International Space Station (ISS) S-Band Corona Discharge Anomaly Consultation

NASA Engineering and Safety Center Technical Consultation Report	Document #: RP-06-115	Version: 1.0
Title: ISS S-Band Corona Discharge Anomaly Consultation			Page #: 1 of 26

December 14, 2006

Figure 6.1-4. Bandpass Filter Tuning Screw and Gap (ref. 5)

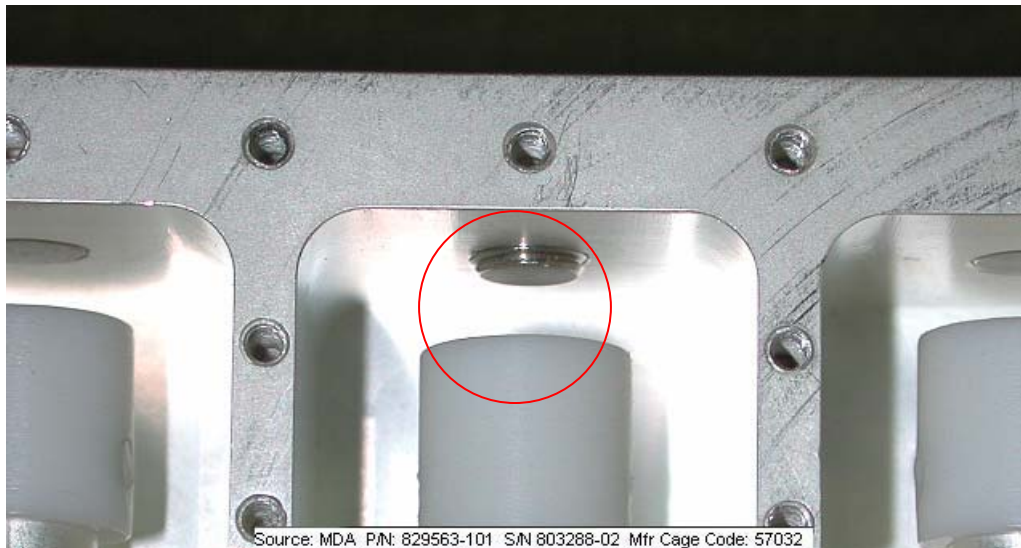
However, corona was judged unlikely in the initial MDA report because of the observed on-orbit condition of four minutes of normal operation followed by degraded service. The end of Section 3.5 (ref. 1) states: "Corona events tend to be a violent occurrence and with permanent damage. Continued operation would not be sustained." For these reasons, a solder joint at the input to the bandpass filter was initially identified by MDA as the most likely proximate cause of the on-orbit ACRFG anomaly.

Figure 7.2-1. Breakdown Voltage versus Pressure for Various Gaps (in air) from Woo Curves (ref. 6)

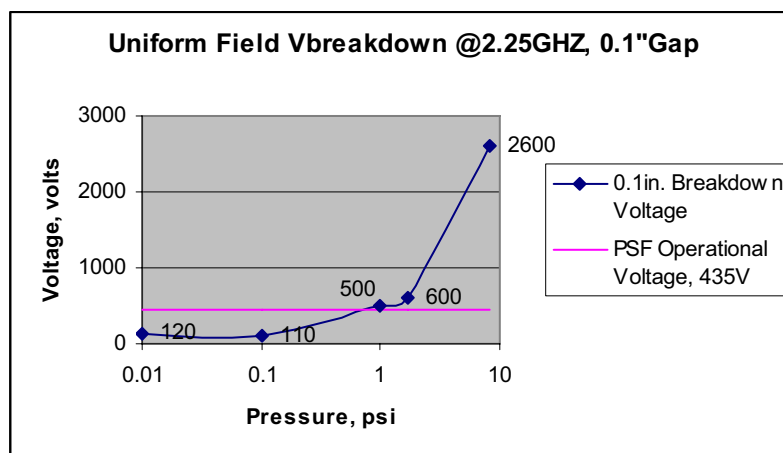
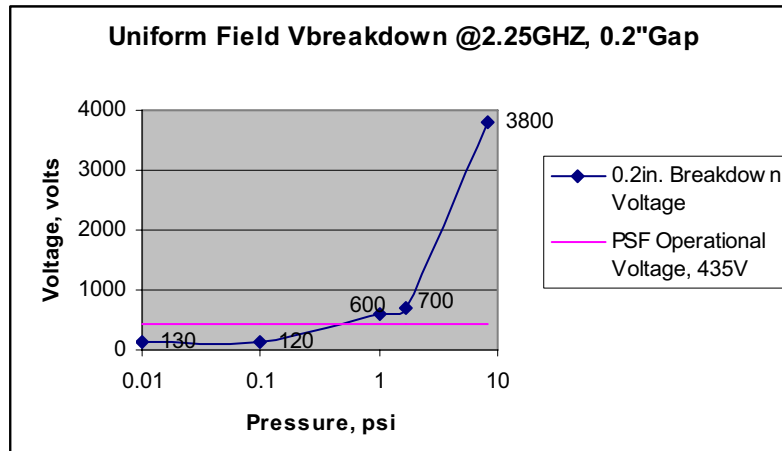
The charts in Figure 7.2-1 show the RF breakdown voltages for a range of pressures in an air environment (refs. 5 and 6). For the purposes of this analysis, N₂ and air are considered

equivalent. As discussed, the actual levels need to be determined by test, as the data is retrieved from the ideal case of uniform fields.

However, it can be seen that the worst case range is between 0.01 and 1 psia and the inception level is so low that corona is likely.

As an engineering judgment, it would be reasonable to assign the following probabilities:

1. At pressures between 0.001 psia and 1 psia, corona is almost certain (>90 percent) for the gap sizes within these assemblies (>90 percent).
2. At pressures of greater than 2 psia, corona at any gap size is unlikely (<10 percent).
3. Between 0.1 and 1 psia, the margin between the operating voltage and corona inception level is essentially non-existent, and the likelihood of corona should be moderate (~70 percent).
4. Below approximately 0.001 psia, multipactor breakdown dominates over ionization breakdown. Corona does not occur in hard vacuum (e.g. <0.00001 psia). However, multipactor breakdown is still possible for small gaps (0.1 inch) in this pressure region, so a breakdown probability of 50 percent would be appropriate.

In the 1 to 2 psia region, the probability of corona is undefined. This is the “knee” of the Paschen curve where the breakdown voltage characteristic changes greatly with small changes in pressure.
